ADDENDUM 1

TO THE DRAWINGS AND SPECIFICATIONS FOR:  
PROJECT NO. 22-22104-00

Rialto Square Theatre  
Restroom Renovation & Expansion

11 NORTH ELEV: WOMEN'S SINK RM 01  
1/4" = 1'-0"

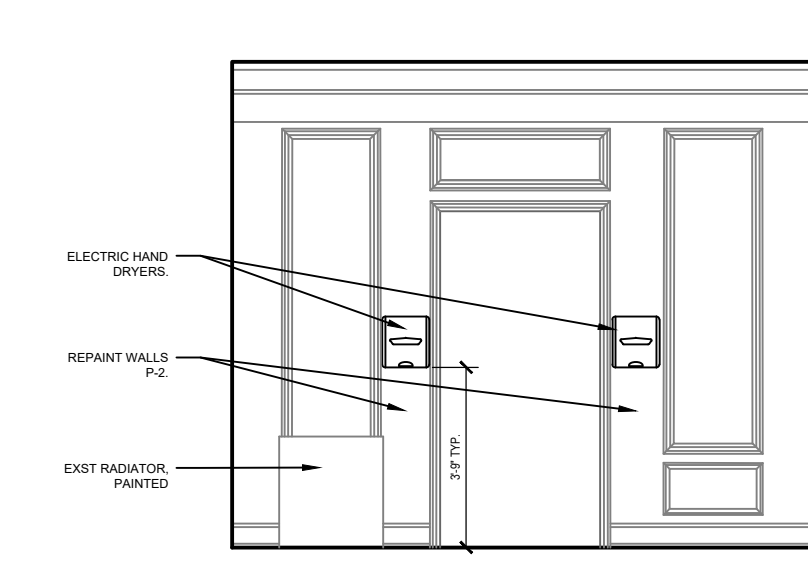
Addendum 1 includes the following reference photos from a similar installation to help clarify work at existing mirrors, 11/A201:

6	Q	11/A201 – the notes about coping the existing moldings and raising them – we are requesting more details
	A	<b>Design intent is as follows: 1. The existing mirror and trim shall remain behind the new low wall 2. A new piece of wood trim should be coped to the existing side moldings and affixed (adhered) to the face of the mirror to give the illusion that the mirror has been shortened</b>  <b>Refer to Addendum 01 for reference photos.</b>
7A	Q	12/A201 – where the electric hand dryers are to be installed – how do we power these? Channel down the wall to the basement? Will the specified hand dryers fit in between the plaster moldings?
	A	<b>As noted in the documents, power should be run up through the back-side (non-decorative side) of the wall. If fishing or channeling is not feasible, conduit should be run up the backside of the wall. In room [1-004] conduit will be concealed by gyp bd wall furring as shown. In room [1-003] new type 3C furred wall can be installed in the area to conceal the conduit.</b>

13 EAST ELEV: WOMEN'S SINK RM 01  
1/4" = 1'-0"

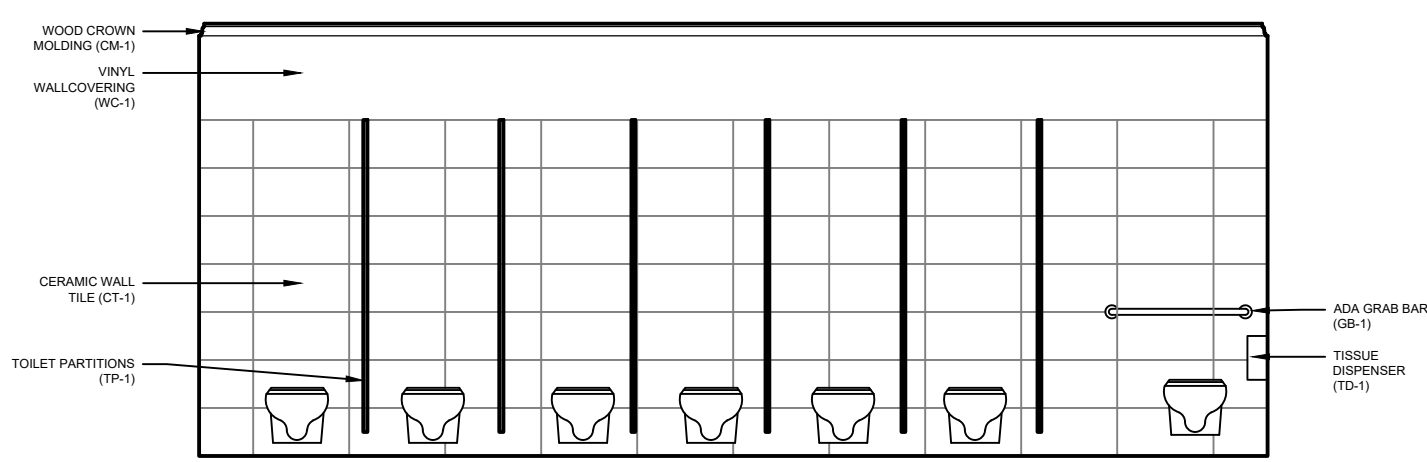
1. Sheet A201
  - a. Detail 1: Wall demolition note added.
  - b. Detail 2:
    - i. Location of wall at door [1-002] revised and dimension added.
    - ii. Spacing of water closets in Rooms [1-003] and [1-004] and toilet partitions revised.
  - c. Detail 3: Plaster ceiling repair removed from contract.
  - d. Detail 13: Elevation updated to include wall revisions at door [1-002].
2. Sheet A202
  - a. Detail 1: Floor demolition note added.
  - b. Detail 2:
    - i. Steel lintel removed from contract
    - ii. "Cased opening" note revised to reference room [1-001]
3. Sheet I101
  - a. Finish Schedule: Revised finish selections for WC-1, CT-2, TP-1.
4. Sheet P101

3 ENLARGED WOMEN'S ROOM REFLECTED CEILING PLAN  
1/4" = 1'-0"

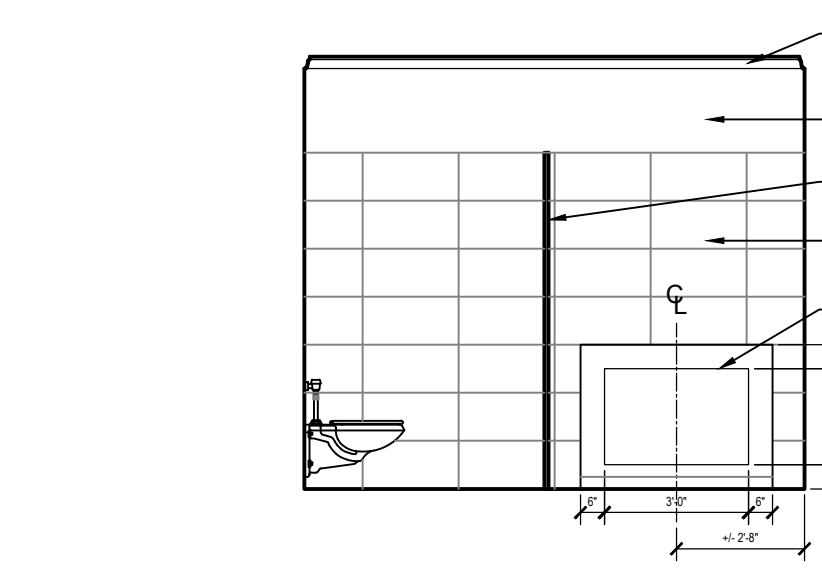
9	Q	Women's Sink Room 01 and Women's Sink Room 02 – plans call for repair of decorative plaster. We need better details and an understanding of what level of repairs are expected
	A	<b><i>This scope of work has been removed from the contract. Refer to Addendum 01</i></b>
10	Q	Demolition plan 1/A202 – there is existing carpet and plywood that need to be removed that are not mentioned on the plans. It looks like we may need to completely re-sheet this floor surface to receive new flooring as well.
	A	<b><i>Remove floor finish. Patch/repair/replace subfloor as necessary to facilitate the installation of new finish. Refer to Addendum 01</i></b>
11	Q	The new opening into the bathrooms from Corridor 1-007 as shown on 2/A202 – we need more information on the steel lintels, and also better details on the new cased opening. We would like to have an elevation shown from the Rotunda area on where the new opening is cut into the wall, and how it fits in with the existing plaster in that area.

2 PARTIAL FIRST FLOOR PLUMBING PLAN - NORTH

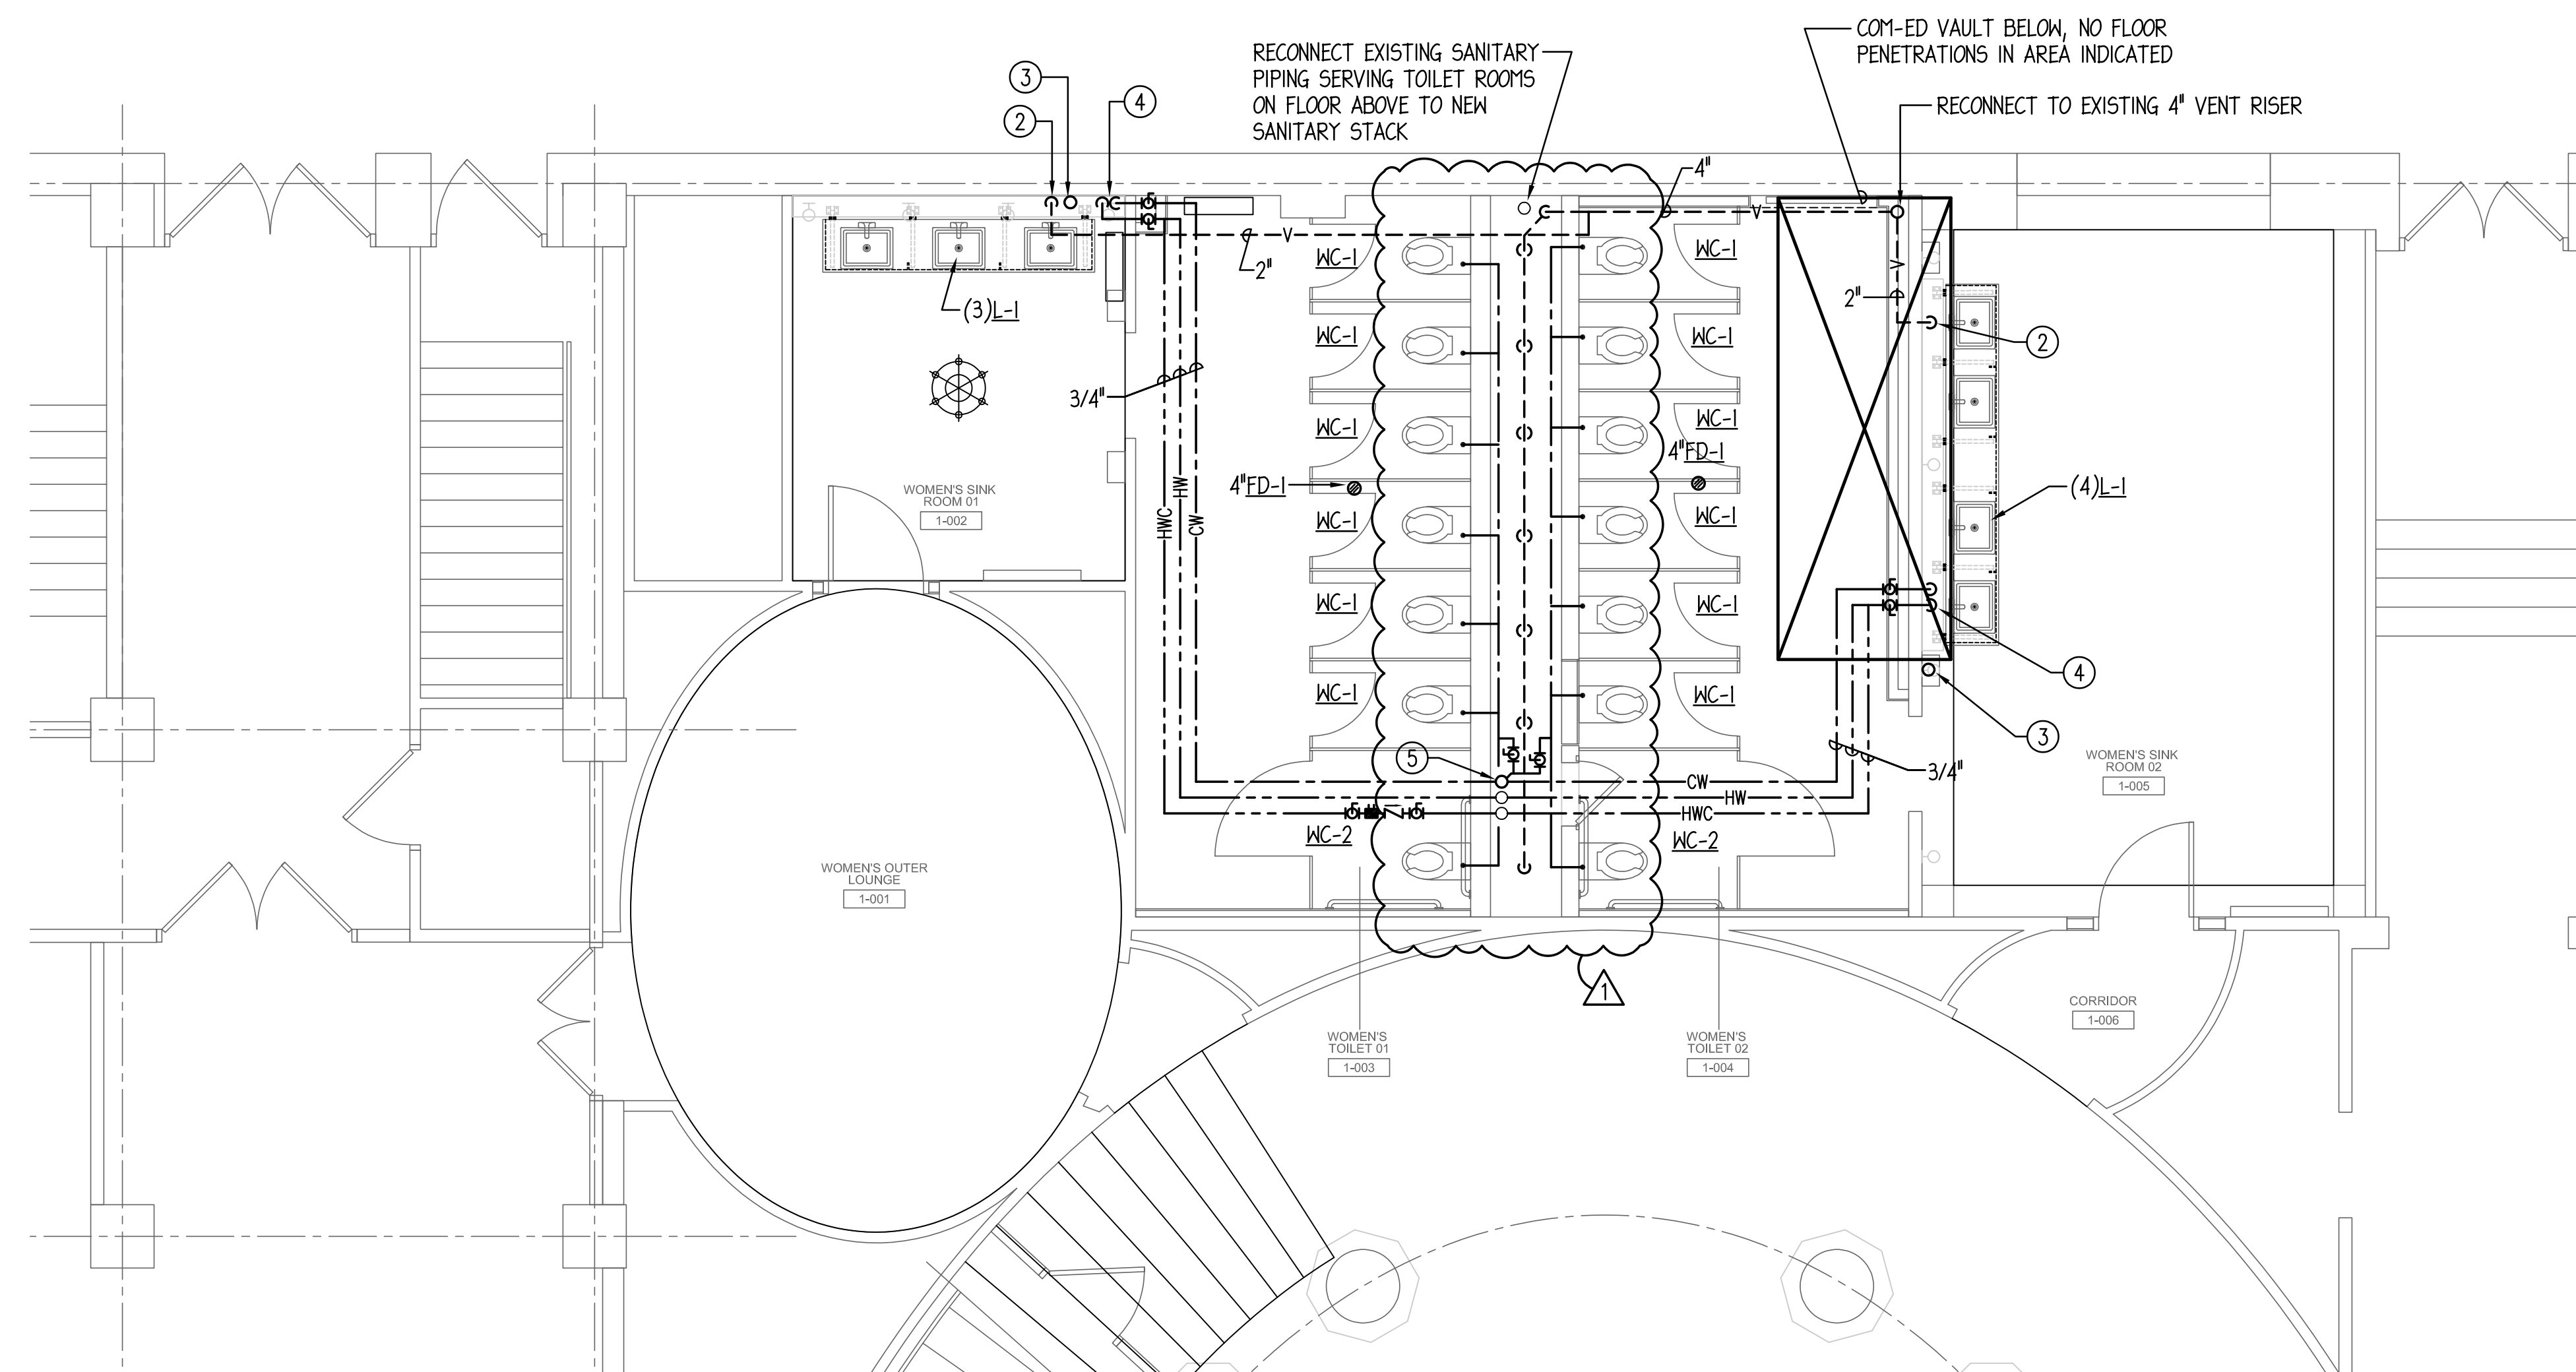
- a. Detail 1: Note added to clarify insulation on suspended sanitary piping is not required.
  - b. Detail 2: Spacing of water closets in Rooms [1-003] and [1-004] revised to be back-to-back.
- 5. Sheet E101:
  - a. Detail 1: Revised occupancy sensor type in [1-003] and [1-004]
- 6. Sheet E102
  - a. Detail 1: Added light switch to [1-008]; added emergency battery light in [1-009]

1 PARTIAL LOWER LEVEL PLUMBING PLAN - NORTH

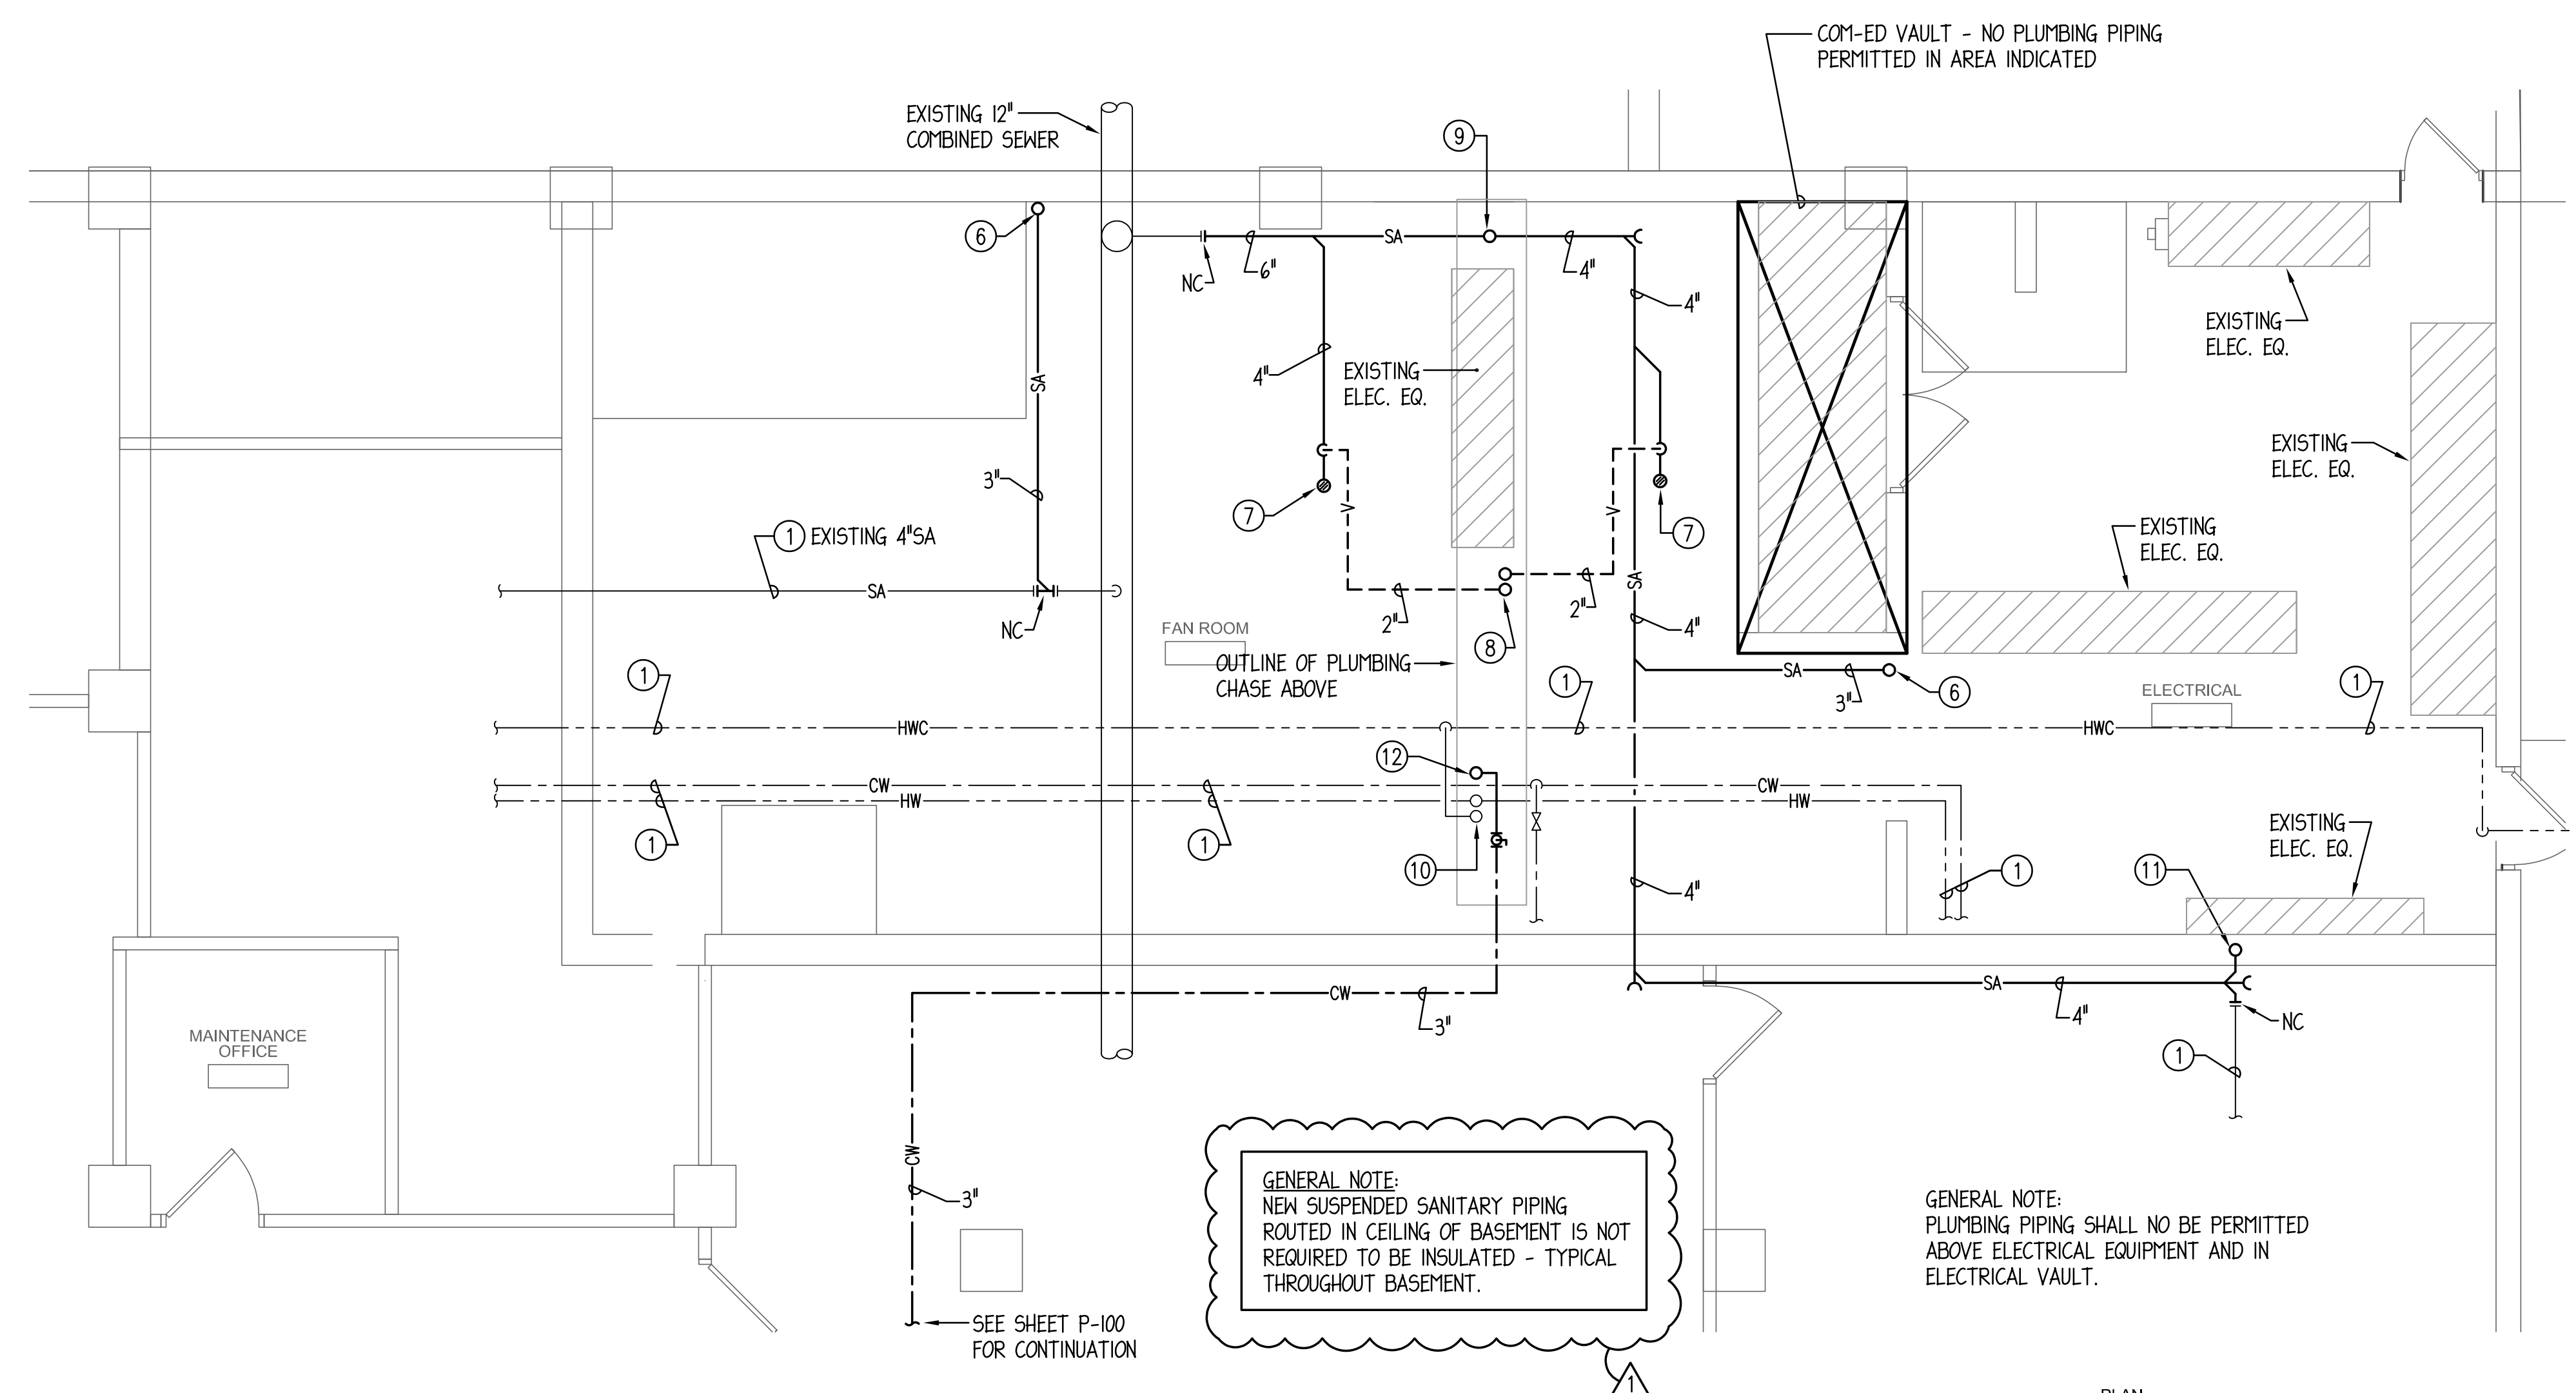
A	<b><i>The steel lintel scope of work has been removed from the contract. New opening shall be similar to that of the opening to room [1-001]. Refer to Addendum 01.</i></b>
12	Q	Please verify that insulation on PVC waste piping is necessary. The suspended horizontal piping is located in the basement.
	A	<b><i>Insulation on suspended sanitary piping is not required. Refer to Addendum 01</i></b>
13	Q	How are we controlling the lights?
	A	<b><i>Lights in ADA/Family Toilet is controlled by wall mounted occupancy sensor/switch. Lights in large restrooms are controlled by ceiling mounted occupancy sensors with a manual override light switch as indicated. - REVISE ceiling mount occupancy sensor type in Women's Toilet 01 &amp; Women's Toilet 02 to be 'sA' in lieu of 'A'. - ADD (1) new light switch to override lights in Men's Room 1-008 on latch side of door 1-008A.</i></b>
14	Q	Drawing E102 in the existing small bathroom, there needs to be an EM light in there by code.

GENERAL NOTE:  
NEW SUSPENDED SANITARY PIPING  
ROUTED IN CEILING OF BASEMENT IS NOT  
REQUIRED TO BE INSULATED - TYPICAL  
THROUGHOUT BASEMENT.
